# UPDATE 5TH NOV 2007

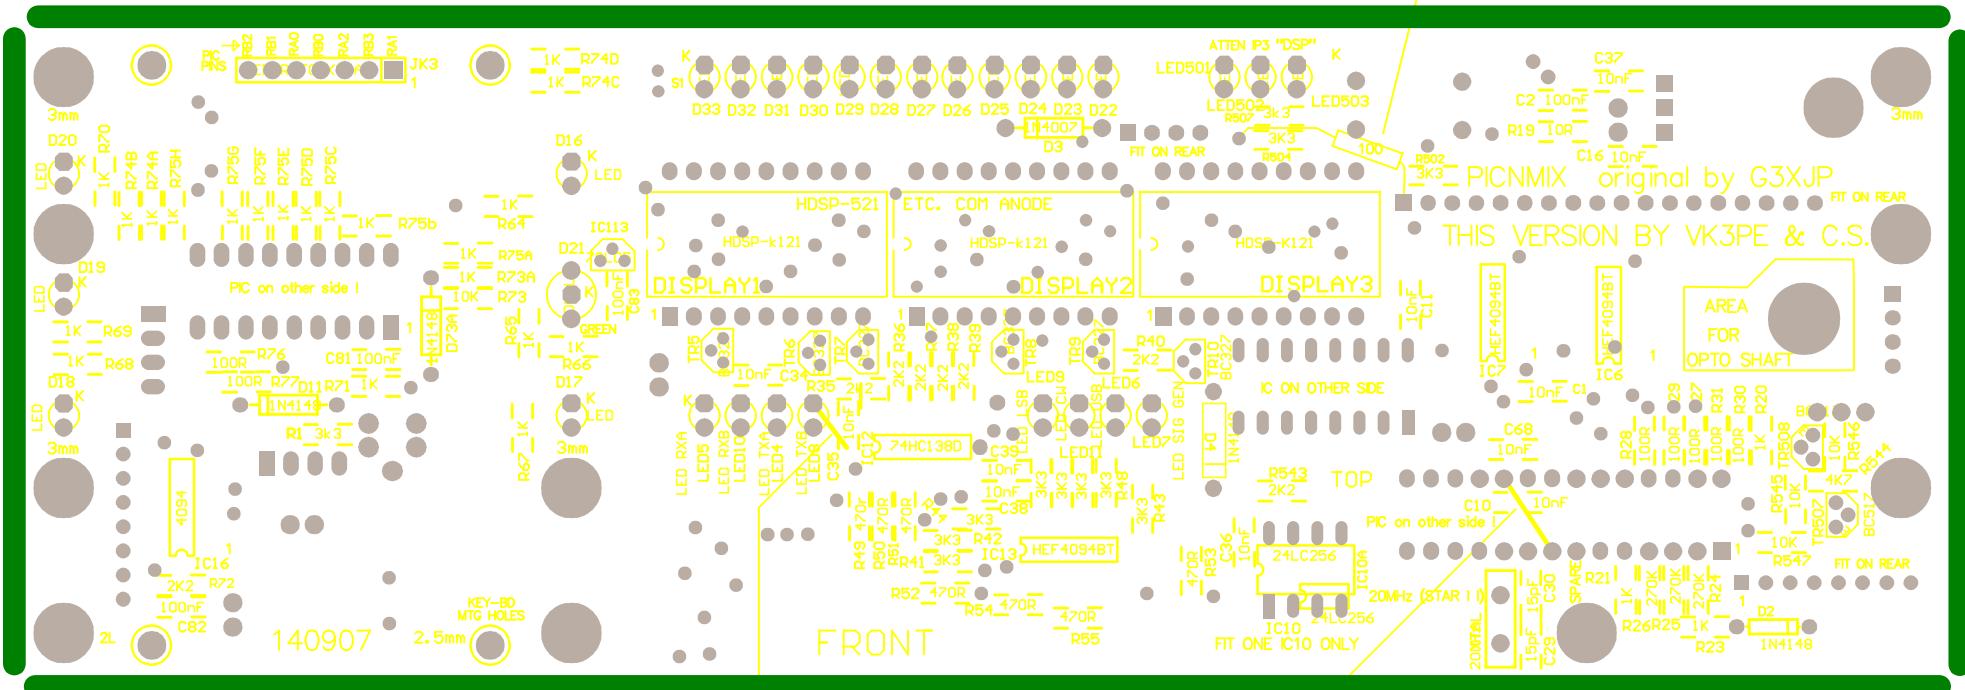
NOTE BC327's (6) are shown REVERSED on this overlay!

Add LINKS as below for correct Grounding.

"R2x" FIT A 100 ohm LEADED RESISTOR FROM "SPARE" TO JK1 PIN 1

5th Nov 07: LINK Pin 19 to pin 8 of PIC socket with a piece of resistor lead.
